UNITED STATES PATENT AND TRADEMARK OFFICE

APPLICATION NO.	FILING DATE	FIRST NAMED INVENTOR	ATTORNEY DOCKET NO.	CONFIRMATION NO.
10/709,661	05/20/2004	Bertil Jonsson	07589.0175.PCUS00	3039

Office Action Summary

DETAILED ACTION

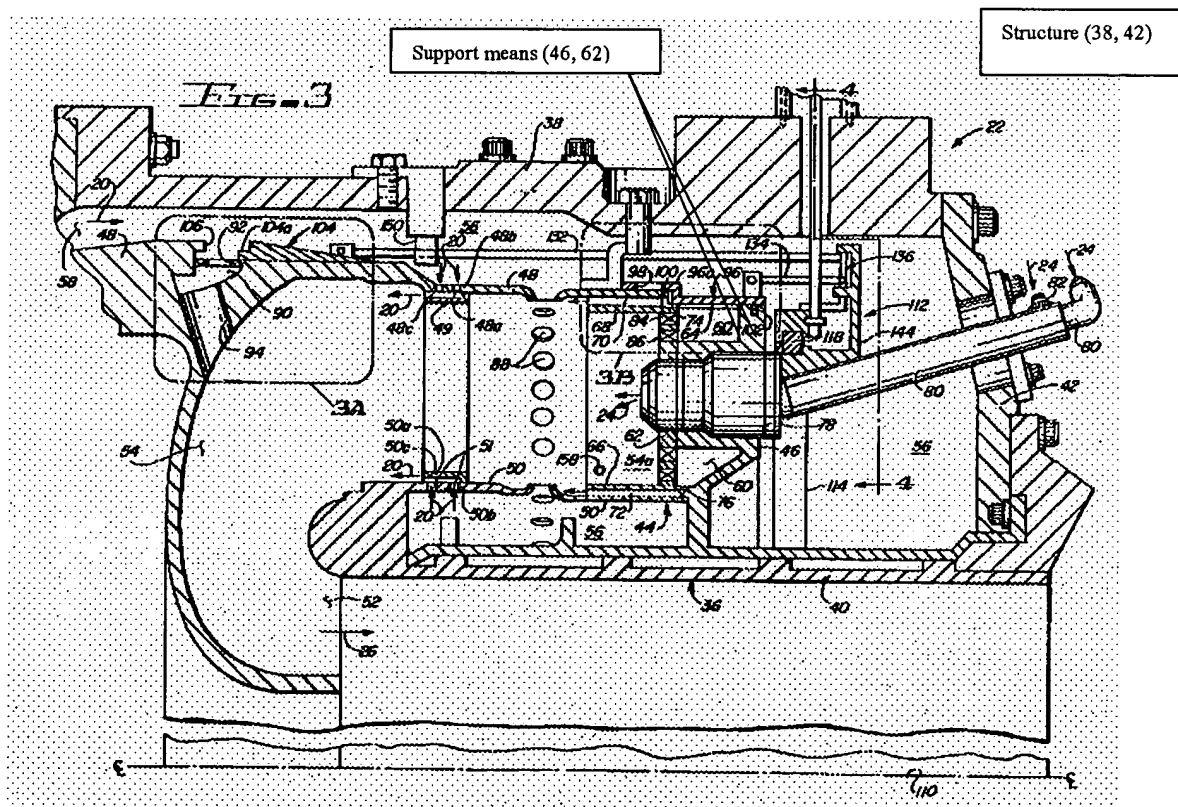
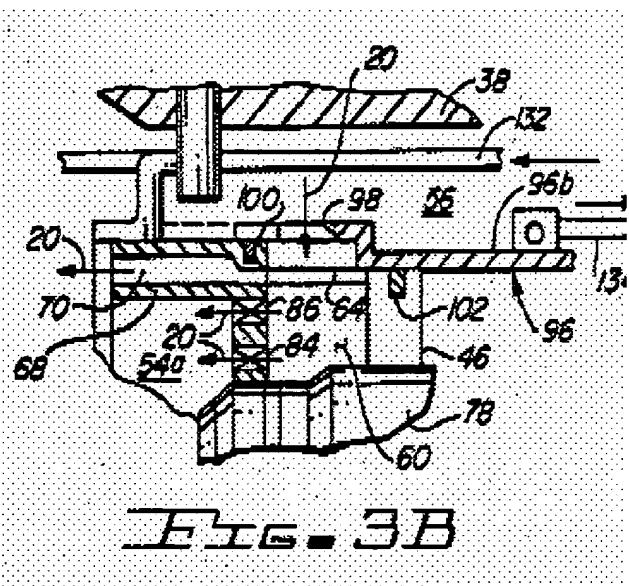
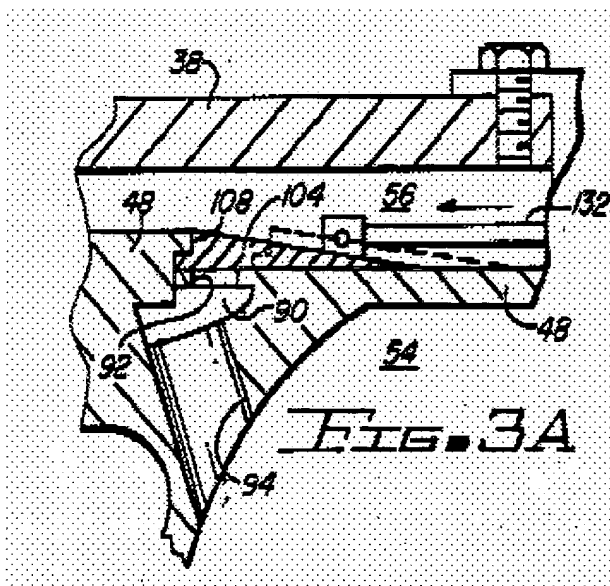
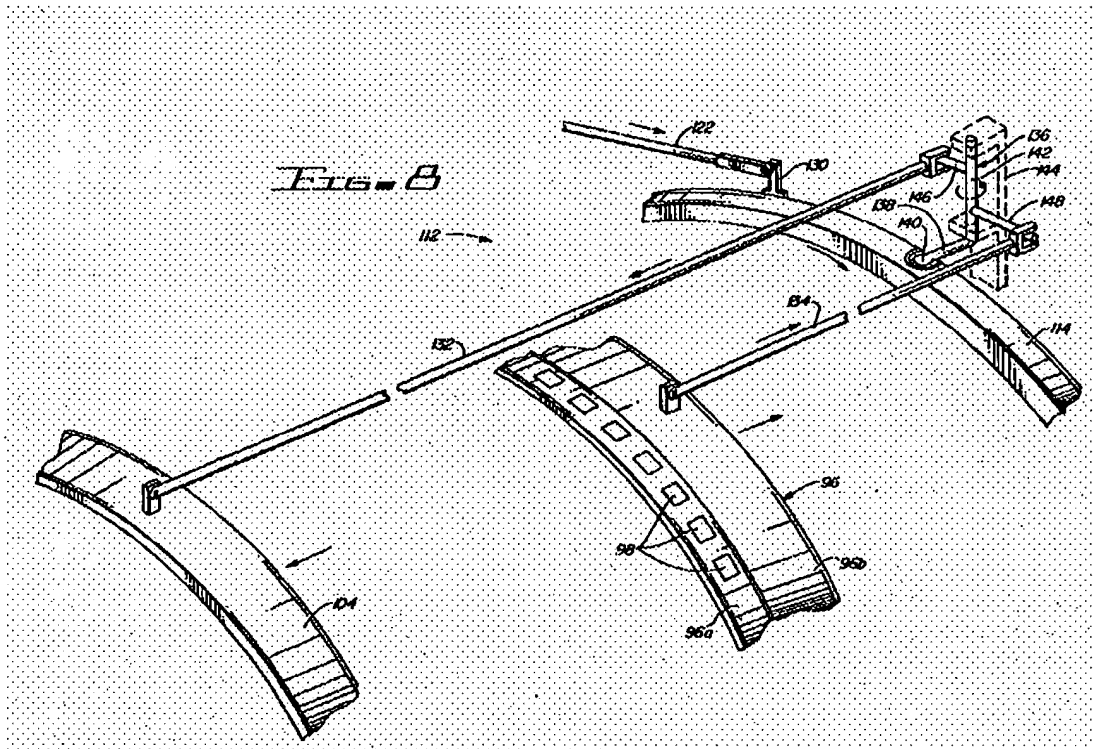
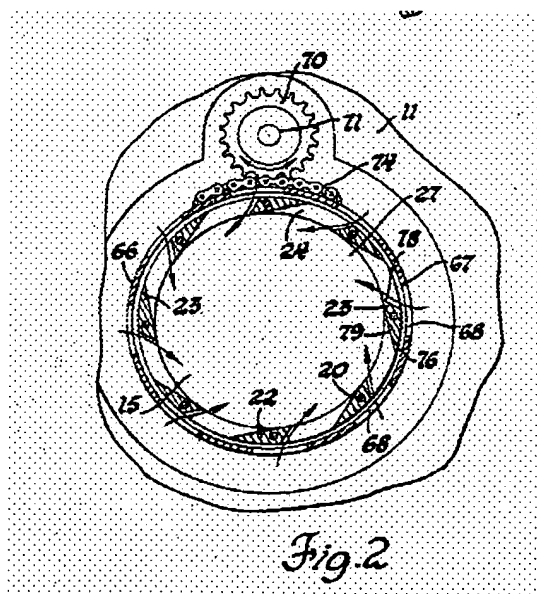
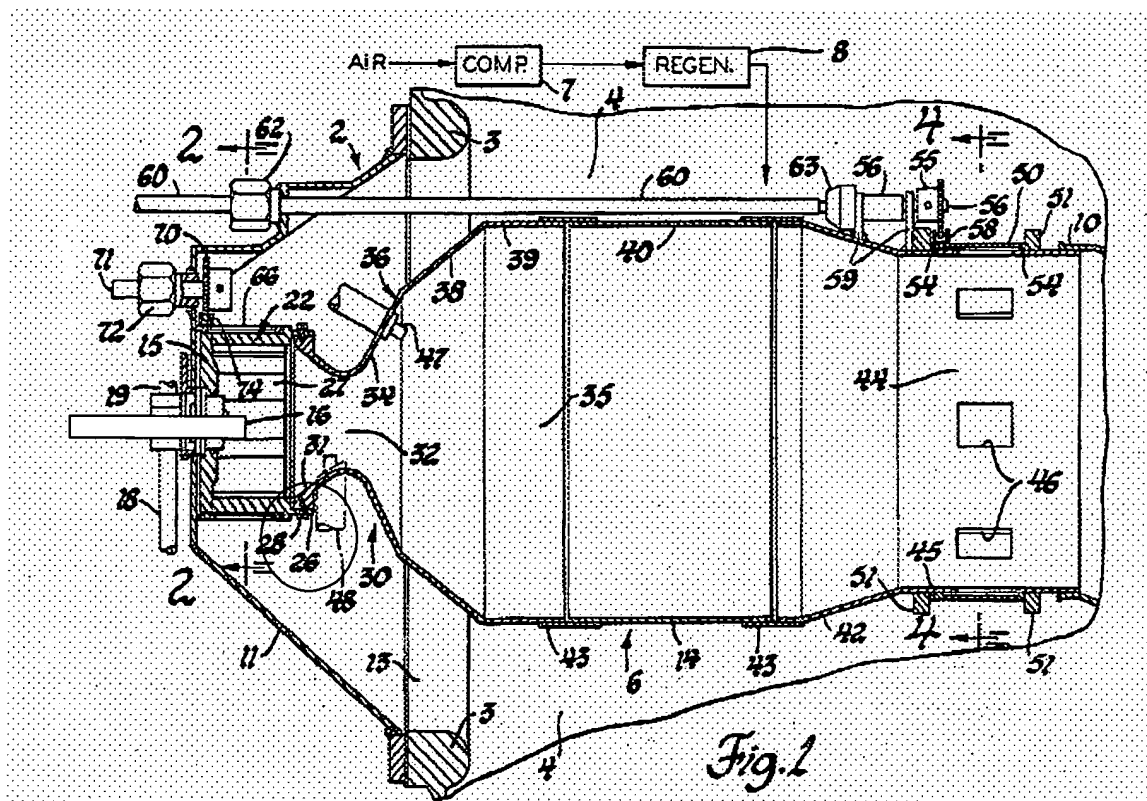
With respect to claim 23, **Mongia** teaches a device for controlling the intake of gas into a combustion zone of the combustion chamber of a gas turbine, said device comprising: a control element arranged outside the combustion chamber; said control element further comprising a first cover means (96) for covering at least a first inlet (64) to the combustion zone, said first cover means being displaceable relative to the combustion chamber, and a support means (46, 62) connected to the first cover means for providing support to the control element, said support means being accommodated interiorly within a structure (38, 42) rearwardly located with respect to the combustion chamber and said support means being substantially concentrically oriented relative to a centerline of the combustion chamber. See particularly **Figures 3, 3a, 3b** and **8** above; and column 5 line 59 to column 6 line 22.

With respect to claim 24, **Mongia** teaches that the control element is exclusively supported on said support means (46, 62) in an operating configuration, without contact with the combustion chamber. See particularly **Figure 3** above.

With respect to claim 26, **Mongia** teaches that the structure (38, 42) in which the support means is accommodated forms at least a part of a combustion chamber cover. See particularly **Figure 3** above.

With respect to claim 27, **Mongia** teaches that the support means, when accommodated in the structure is radially oriented outside a pilot distributor (78) to the combustion chamber. See particularly **Figure 3** above.

With respect to claim 29, **Mongia** teaches that the support means has a circular cross-sectional shape. See particularly **Figure 3** above.

With respect to claim 30, **Mongia** teaches that the first cover means has at least one recess (98) extending through a wall thereof in a substantially radial direction of the control element. See particularly **Figure 8** above.

With respect to claim 31, **Mongia** teaches that at least one recess (98) in the first cover means and first inlet 64 to the combustion chamber, when in registration with one another, are configured to form a through-duct for gas passing from outside the combustion chamber to inside the combustion chamber. See particularly **Figure 3b** above.

With respect to claim 34, **Mongia** teaches that the wall of the first cover means is ring-shaped and said at least one recess (98) extends therethrough. See particularly **Figure 8** above.

With respect to claim 38, **Mongia** teaches that the first cover means is arranged at a greater radial distance from a central axis through the control element than the support means (46, 62). See particularly **Figure 3** above.

With respect to claim 39, **Mongia** teaches that the first inlet 64 extends through a combustion chamber wall and forms a gas inlet into at least one swirl (84, 86) arranged in the combustion chamber. See particularly **Figure 3** above.

With respect to claim 40, **Mongia** teaches that the control element further comprises a second cover means (104) configured to cover at least a second inlet (92) to the combustion zone, the at least one second inlet being arranged at a distance from the at least one first inlet in a longitudinal direction of the combustion chamber. See particularly **Figure 3b** above.

With respect to claim 45, **Mongia** teaches that the second cover means is connected to the first cover means by at least one arm (142). See particularly **Figure 8** above.

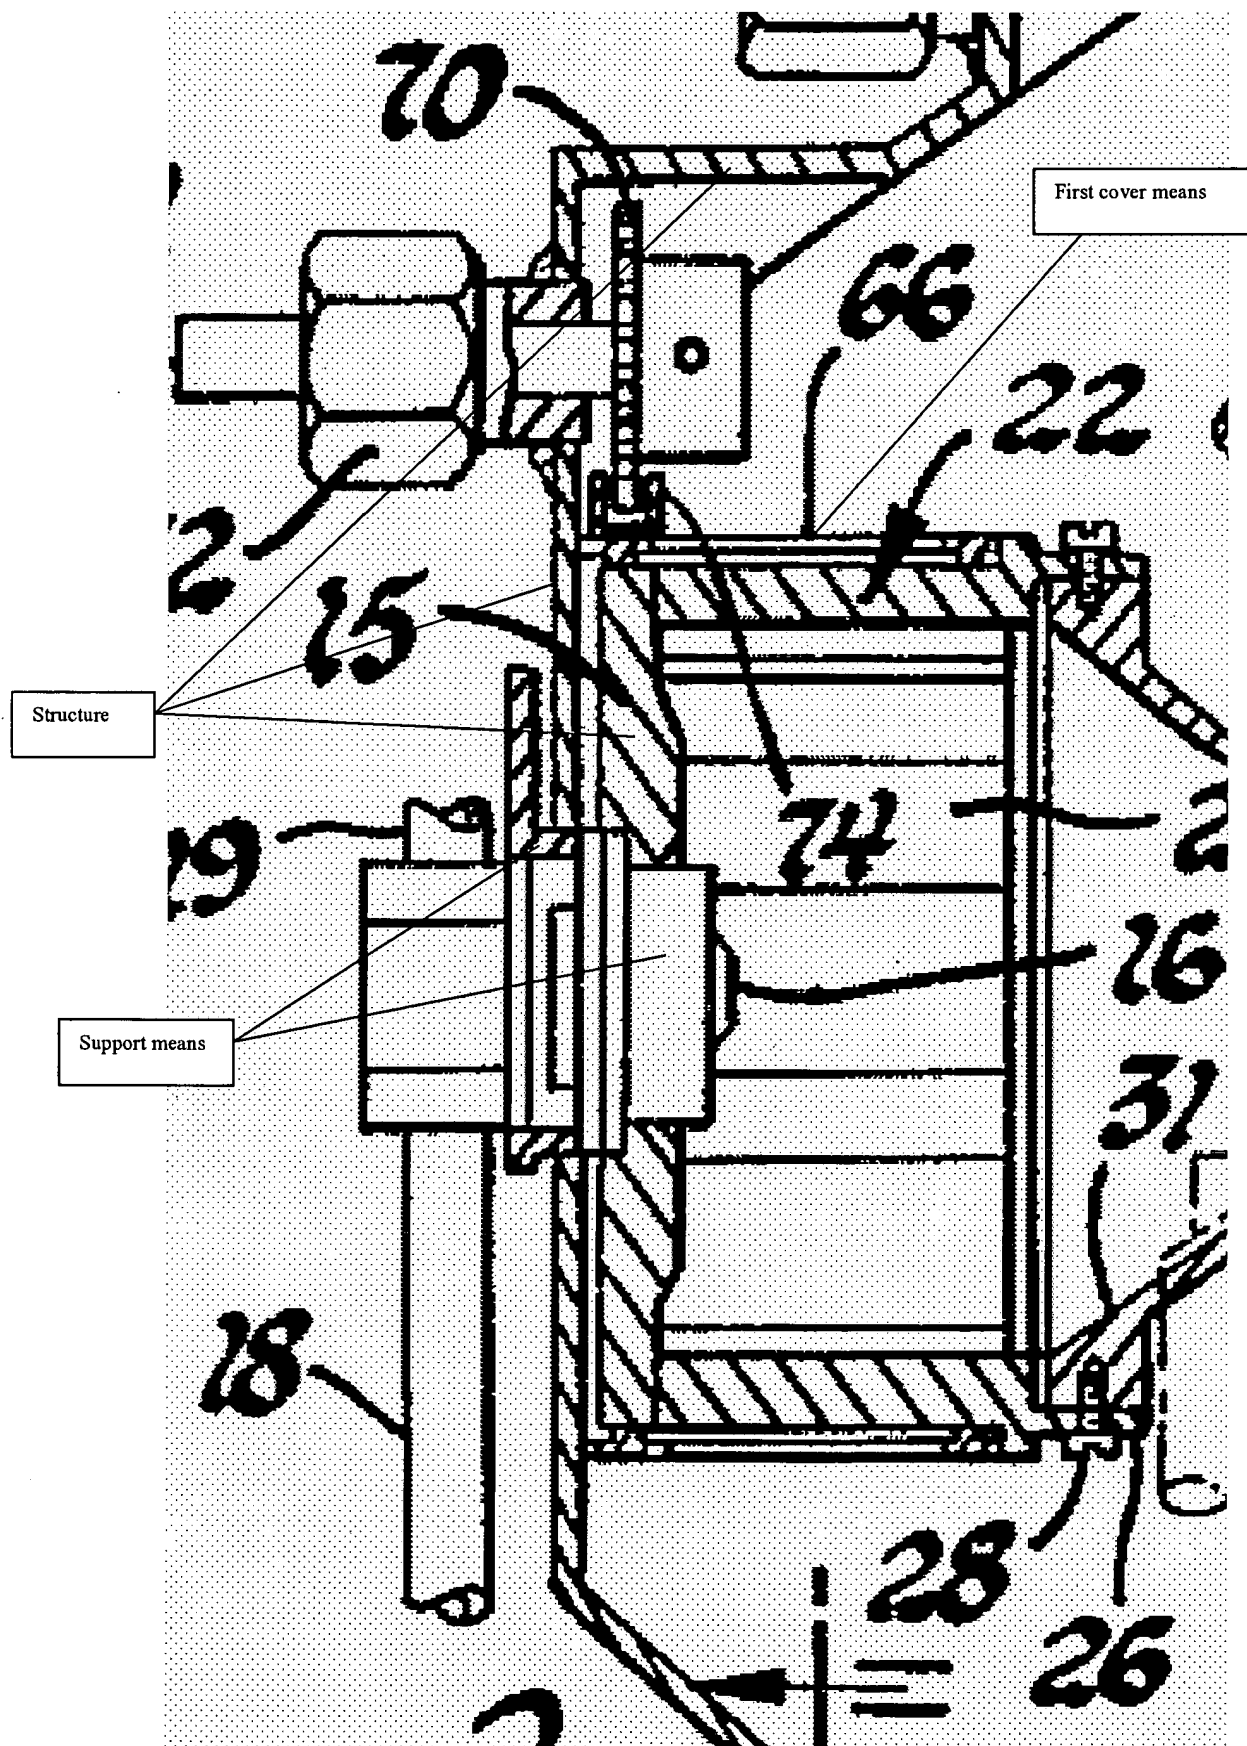
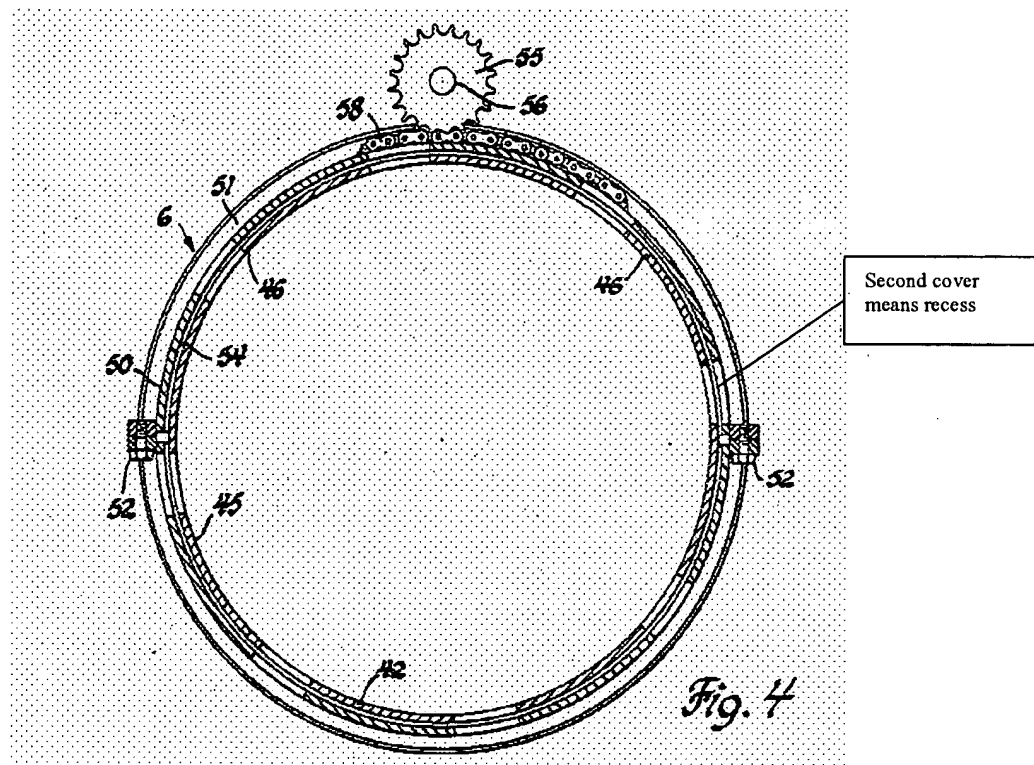
With respect to claim 23, **Cornelius** teaches a device for controlling the intake of gas into a combustion zone of the combustion chamber of a gas turbine, said device comprising: a control element arranged outside the combustion chamber; said control element further comprising a first cover means (66) for covering at least a first inlet (24) to the combustion zone, said first cover means being displaceable relative to the combustion chamber, and a support means (16) connected to the first cover means for providing support to the control element, said support means being accommodated interiorly within a structure (11, 15) rearwardly located with respect to the combustion chamber and said support means being substantially concentrically oriented relative to a centerline of the combustion chamber. See particularly **Figures 1 and 2** above.

With respect to claim 24, **Cornelius** teaches that the control element is exclusively supported on said support means in an operating configuration, without contact with the combustion chamber. See particularly **Figures 1 and 2** above.

With respect to claim 26, **Cornelius** teaches that the structure in which the support means is accommodated forms at least a part of a combustion chamber cover. See particularly **Figures 1 and 2** above.

With respect to claim 29, **Cornelius** teaches that the support means has a circular cross-sectional shape. See particularly **Figures 1 and 2** above.

With respect to claim 30, **Cornelius** teaches that the first cover means has at least one recess (68) extending through a wall thereof in a substantially radial direction of the control element. See particularly **Figure 2** above.

With respect to claim 31, **Cornelius** teaches that at least one recess (68) in the first cover means and first inlet 24 to the combustion chamber, when in registration with one another, are

configured to form a through-duct for gas passing from outside the combustion chamber to inside the combustion chamber. See particularly **Figures 1 and 2** above.

With respect to claim 34, **Cornelius** teaches that the wall of the first cover means is ring-shaped and said at least one recess (68) extends therethrough. See particularly **Figures 1 and 2** above.

With respect to claim 35, **Cornelius** teaches that the first cover means is rotatable relative to the combustion chamber. See particularly **Figures 2** above and column 4 line 58.

With respect to claim 37, **Cornelius** teaches that the control element is rotatable relative to the structure within which the support means is accommodated. See particularly **Figures 1 and 2** above.

With respect to claim 38, **Cornelius** teaches that the first cover means is arranged at a greater radial distance from a central axis through the control element than the support means. See particularly **Figure 1** above.

With respect to claim 40, **Cornelius** teaches that the control element further comprises a second cover means (50) configured to cover at least a second inlet (46) to the combustion zone, the at least one second inlet being arranged at a distance from the at least one first inlet in a longitudinal direction of the combustion chamber. See particularly **Figure 4**.

With respect to claim 41, **Cornelius** teaches that the second cover means has at least one recess that extends in a substantially radial direction through a wall thereof. See particularly **Figure 4**.

With respect to claim 42, **Cornelius** teaches that at least one recess in the second cover means and the second inlet (46) to the combustion chamber, when in registration with one another, are configured to form a through-duct for gas passing from outside the combustion chamber to inside the combustion chamber. See particularly **Figure 4**.

With respect to claim 43, **Cornelius** teaches that the second cover means is in the shape of a ring with said at least one recess extending through a wall thereof. See particularly **Figure 4**.

With respect to claim 44, **Cornelius** teaches that the second cover means is rotatable relative to the combustion chamber. See particularly **Figure 4**.

On page 9 applicant argues that “**Cornelius**’413 does not disclose a support means connected to the first cover means for providing support to the control element, said support means being accommodated interiorly within a structure rearwardly located with respect to the combustion chamber”. However, as clearly shown on marked-up Figure 1 of **Cornelius** (see page 7 of this office action), **Cornelius** does teach the limitations being argued, that is, **Cornelius** discloses a support means (16) connected (indirectly through element 15) to the first cover means (66) for providing control for the control element, said support means (16) being accommodated

interiorly within a structure (See marked-up Figure 1 above) rearwarly located with respect to the combustion chamber.

Element 16 of Cornelius provides indirectly at least some support to the first support means 66.

Element 66 is inserted within the structure (15, 11).
